CALIFORNIA COASTAL COMMISSION

STAFF REPORT: REGULAR CALENDAR

APPLICATION NO.: 4-97-040

APPLICANT: County of Santa Barbara, General Services Dept., Facilities Services

BASIC CONCEPT SKETCH

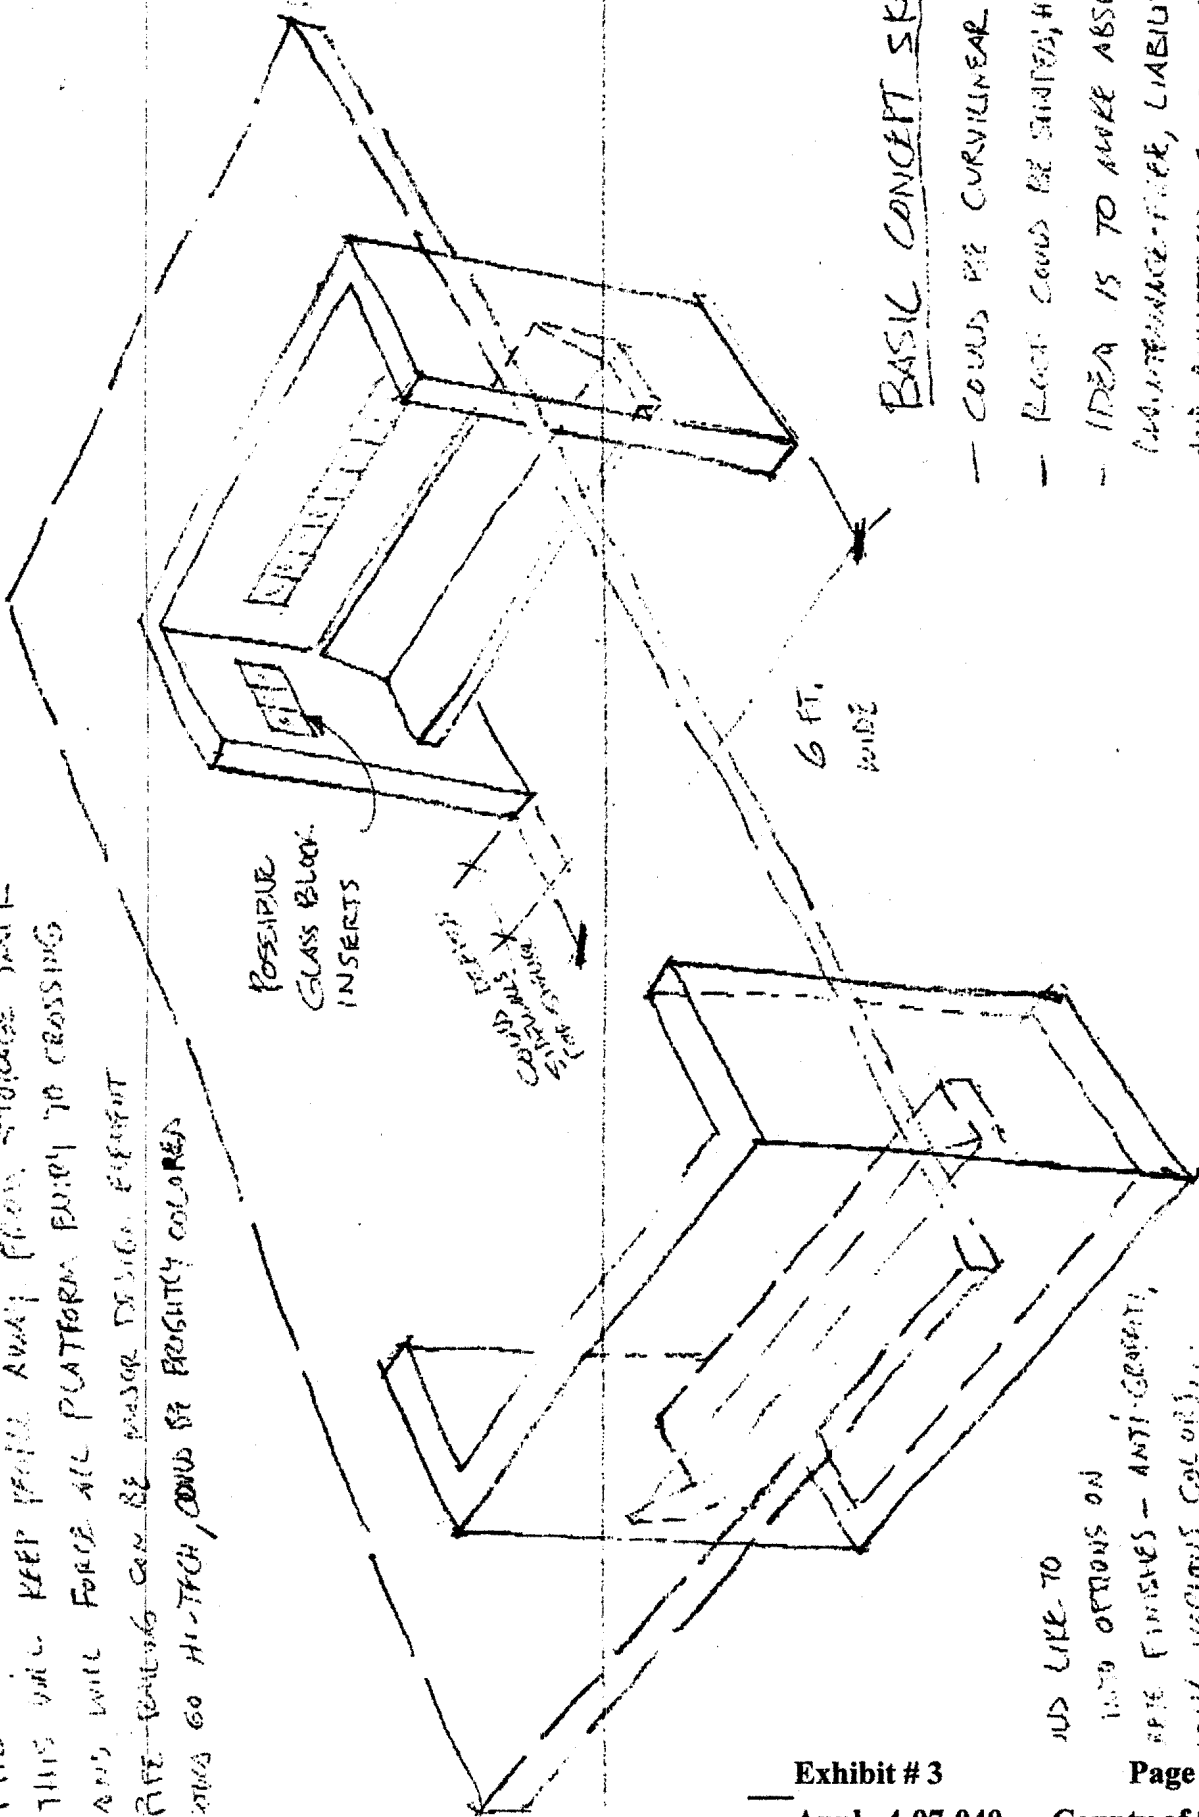
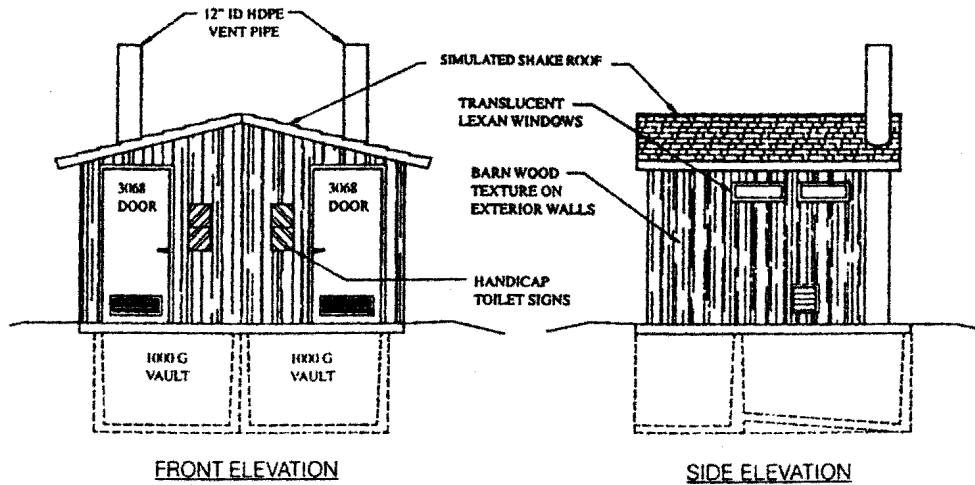
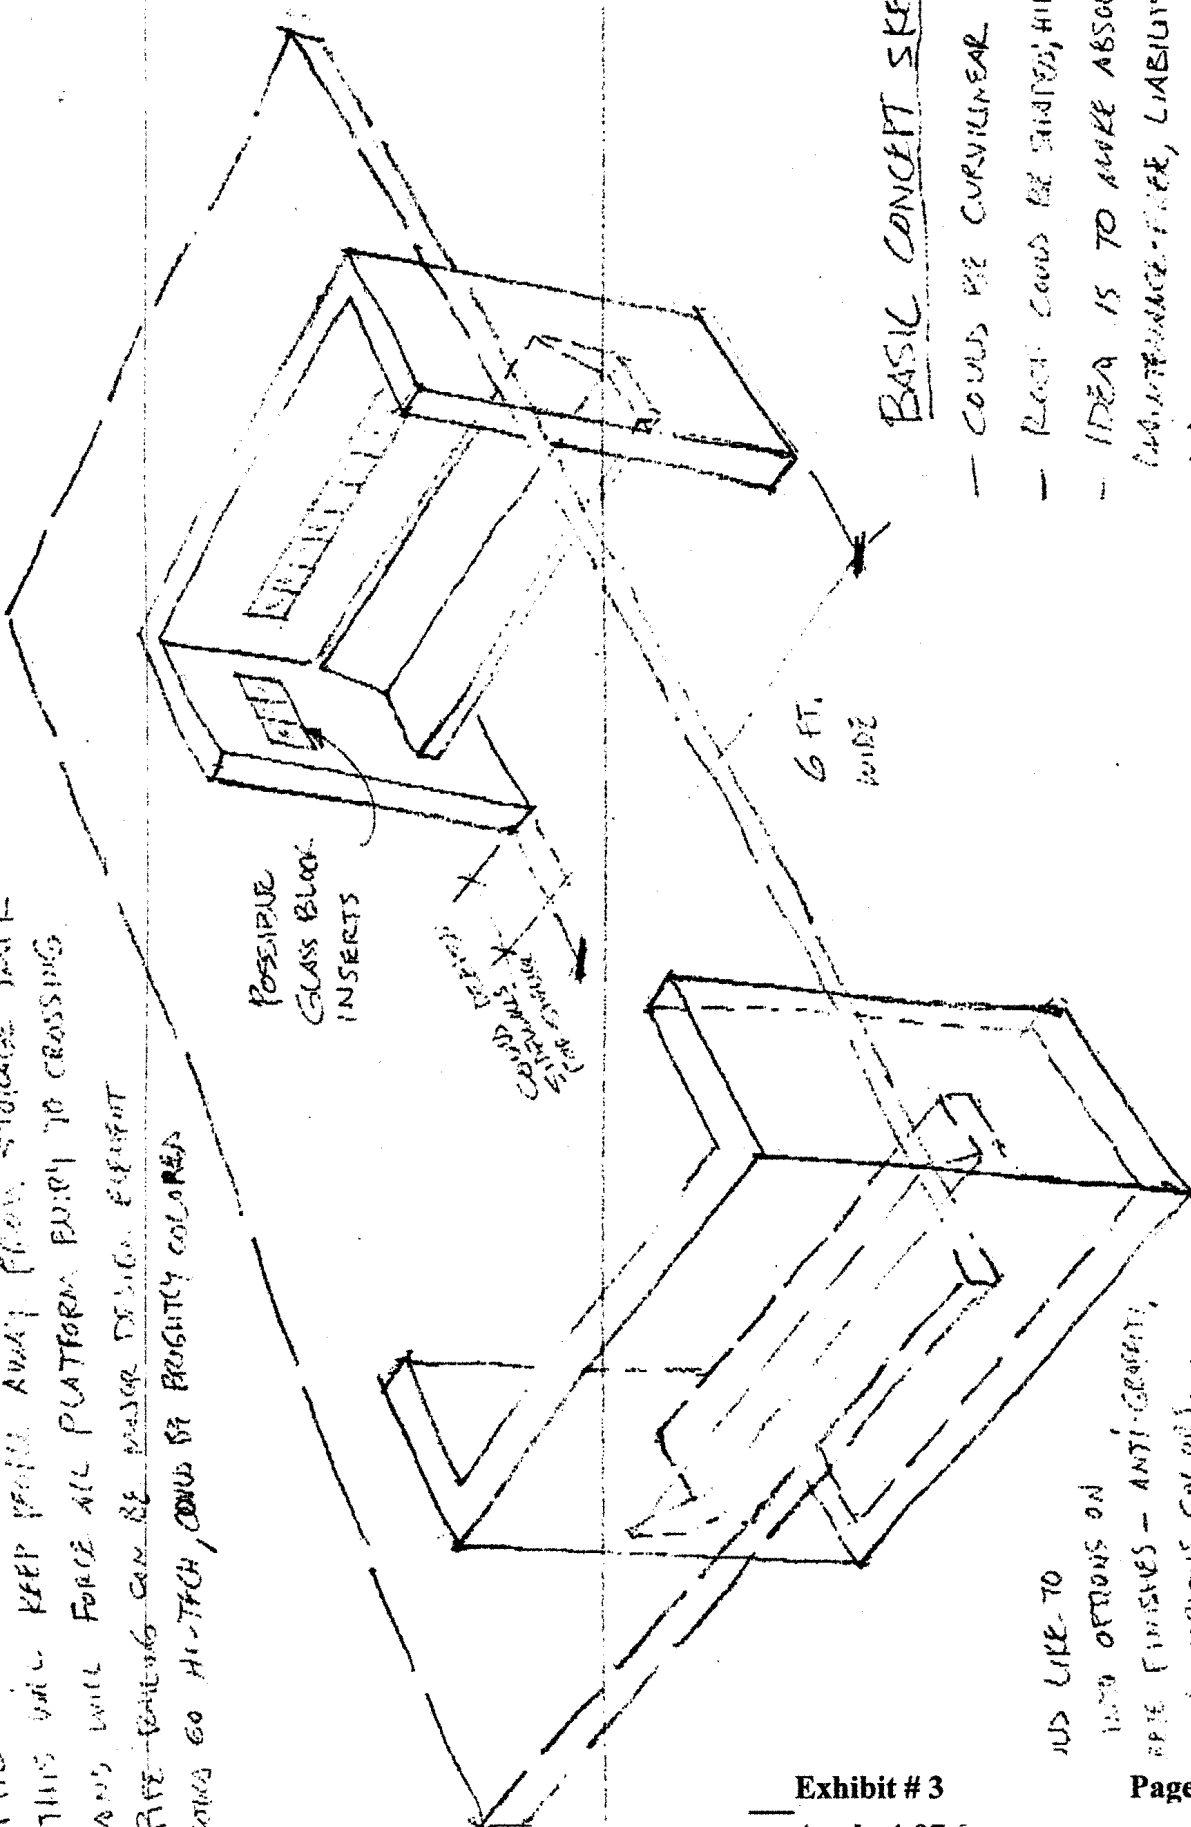
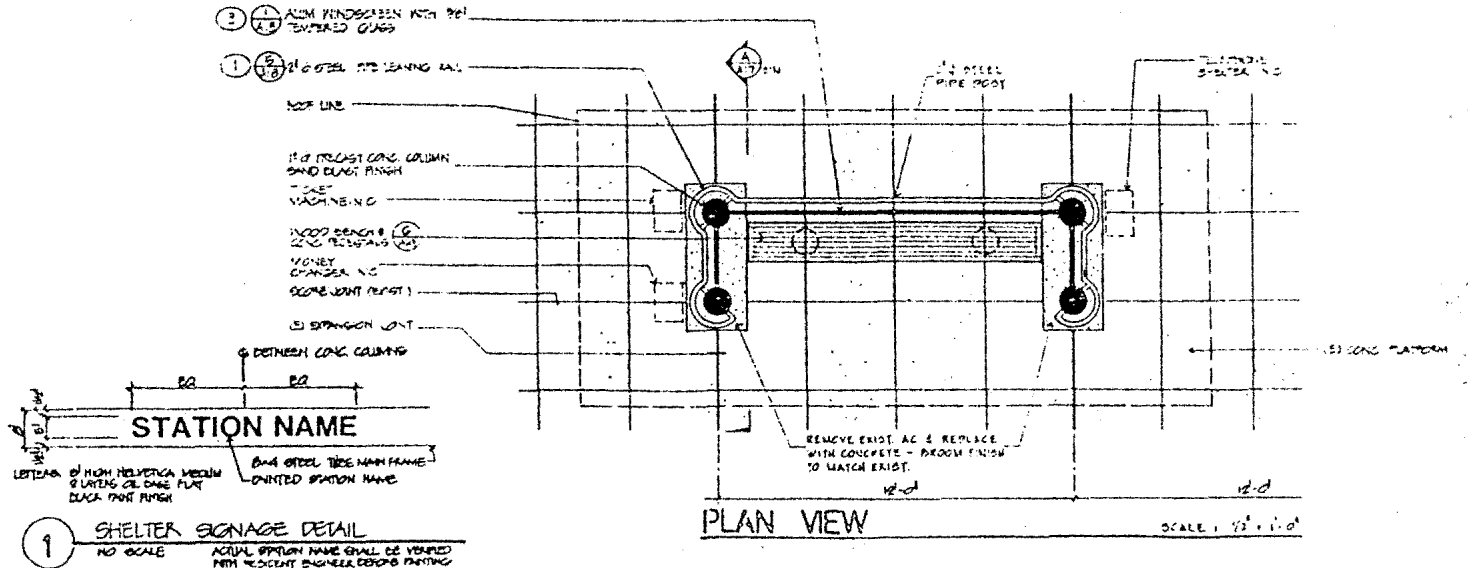
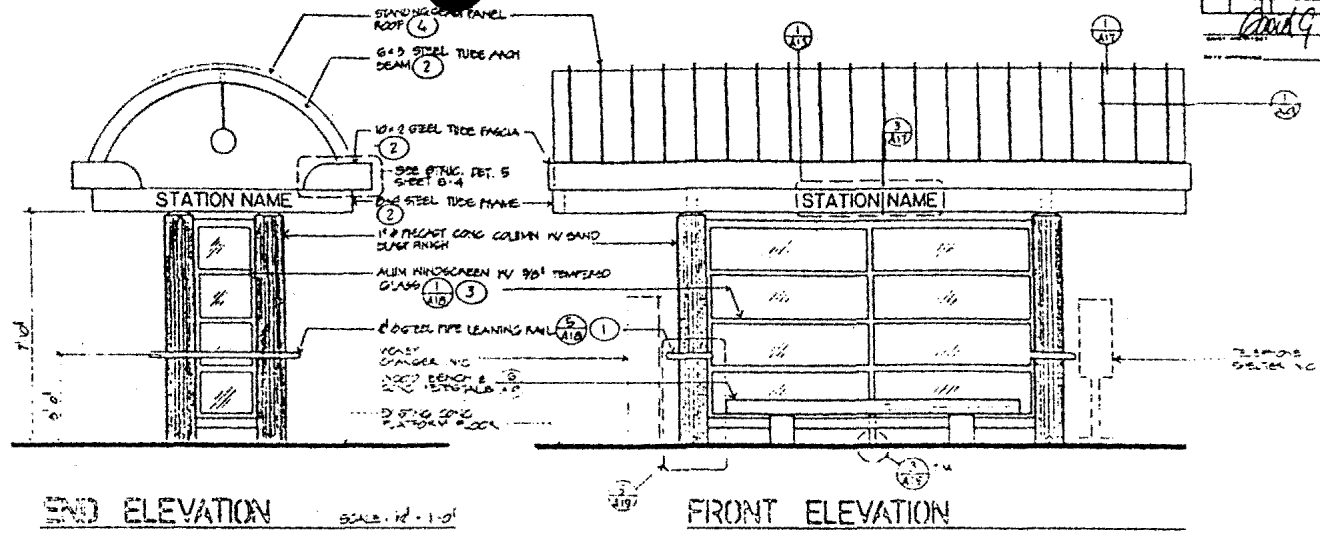
Initially the project contained five canopies approximately 4 ft. x 12 ft. (11 ft. ht.) to be erected equidistant on the 800 feet long platform. Each canopy will consist of four pre-cast concrete sand-blasted columns supporting a tubular steel frame with a seam panel roof. The space between the columns will be in-filled with aluminum windscreen frame with tempered glass and a wooden bench. Around the columns and the windscreen would be a steel pipe leaning rail. The tempered glass infill would allow for limited views of the beach and ocean. (See **Exhibit #3, page 1**) This design proposal (Canopy 1) was made when the application was submitted to the South Central Coast office on March 6, 1997. On April 18, 1997, the applicant amended the application by sending a revised design for the canopies. (See **Exhibit #3, page 2**) The revised design (Canopy 2) will be 6ft. wide and made entirely of concrete. There was no dimension for the length on the sketch. Through proportional derivation of the isometric sketch, the long dimension would be approx. 18 ft. and the height would be 8 ft.. On April 23, 1997, the applicant further amended the application by sending another revised design for the canopies. (See **Exhibit #3, page 3**) The revised design (Canopy 3) will be 5 ft. x 25 ft. (8 ft. ht.) and made entirely of concrete, except for the 4 in. thick glass block infill. The glass block would only allow for the passage of light, but hinder any view of the beach or ocean. There was no change in the number of canopies and their spacing on the platform in both the revisions. Section 3 of the "Standard Specifications for Unstaffed Amtrak Stations in California", (**Exhibit #3, page 4 &5**) states:

The Commission finds that the "specifications" established by Amtrak provides ample room for flexibility in the design of "shelters". It does not define "small" or "large" shelters. Considering the anticipated peak hour passenger usage for Surf (as compared with Santa Barbara) the Commission infers the need for only one "small" shelter. The Amtrak "specifications" also provide the latitude to the designer in placing the "shelter" near or adjacent to the platform. All the designs of the canopies will restrict the continuous views of the beach and the ocean when observed from the parking area. Projecting vision lines from the parking lot facing west, (allowing for the block in views due to the mound/slope of sand south of the parking area as shown in **Exhibit #3, page 6**), it is apparent that any canopy placed within the viewshed created in the angle facing west would restrict views of the public. The only part of the platform which do not fall within the viewshed is the southern half (425 ft.) containing two canopies. Canopies 2 and 3 would be approx. twice the size of Canopy 1 and concrete monoliths, visually bulky and intrusive to coastal views. It is also not visually compatible with the character of the surrounding area. Members of the public have expressed to Commission staff that they enjoy the visual qualities of Surf beach and Pacific ocean by sitting in their parked vehicles at the parking area (see public comments in the file for CD-12-94). If the Commission were to approve only two canopies (Canopy 3) on the Southern half of the platform, however visually intrusive they may be, does not provide the applicant an opportunity to revise the design in consistent with the visual resources of Coastal Act policies, through an amendment.

The applicant's agent has verbally communicated to staff (pers. comm. April 24, 1997) that the design of Canopy 2 is not final and might be revised again, before the Commission meeting on May 16, 1997. In denying the proposed platform with any canopies, the Commission finds, it is in the best interest of the applicant to be given the opportunity to redesign and locate the canopies, consistent with policies of the Coastal Act. As currently designed and located, the proposed canopies will interfere with public views of the shoreline and are, therefore, inconsistent with the visual policies of the Coastal Act. The Commission is conditioning its approval of this application, to require submittal of revised plans for the platform excluding the construction of the canopies. In conclusion, as conditioned, the project would not adversely affect scenic public views and would be consistent with the requirements of Section 30251 of the Coastal Act.

9. Visual Resources: Prior to the issuance of a permit, the applicant shall submit to the Executive Director, for his review and approval, revised plans of the platform without canopies.
